Memo

Re: Response to December 31, 2021 Peer Review Letter from Henry Nover, PE

Notice of Intent Supplemental Documentation (DEP File # 273-0408) Submittal

Shingle Mill Multi-Family Development, 0 Pond Street, Rockland, MA

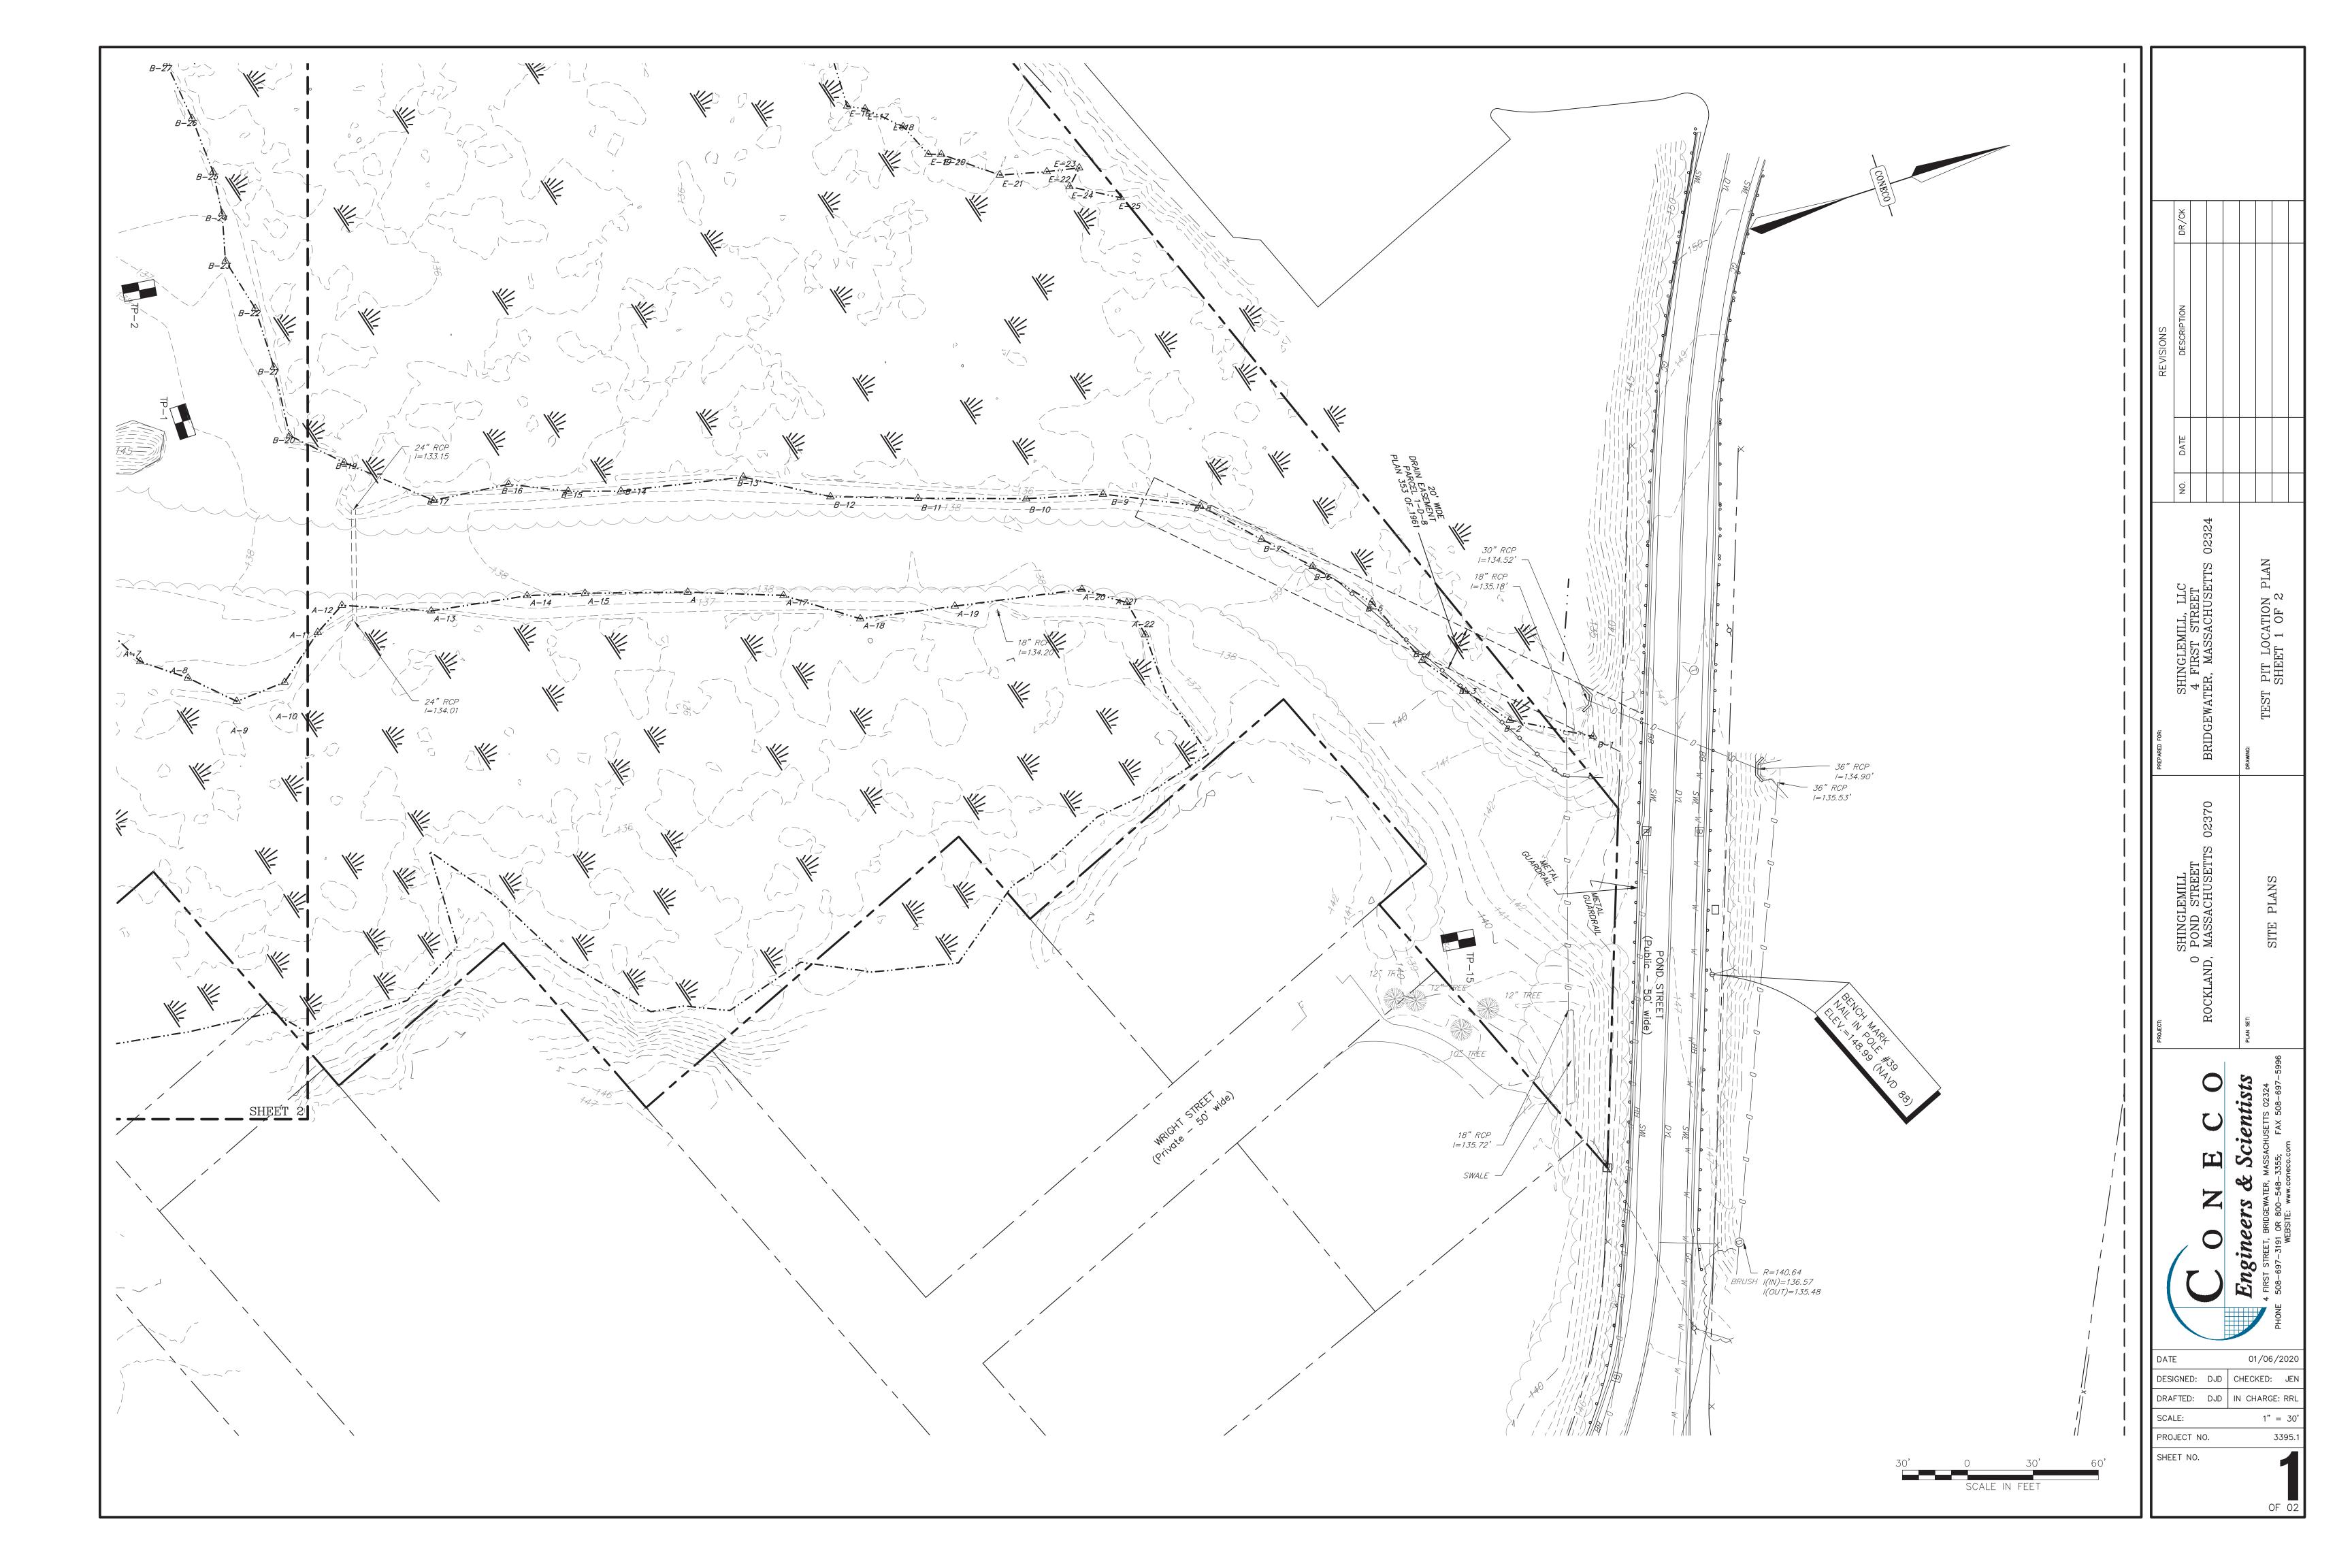
Maintenance Access to Stormwater Wetland 1

The gravel access ramps to Stormwater Wetland 1 are more gradual and the width of the access perimeter road along the back of the Stormwater Wetland has been increased form 7 feet to approximately 15 feet.

The proposed snow storage area at Stormwater Wetland 1 as been relocated. Proposed snow storage areas are also east and south of the Community Building.
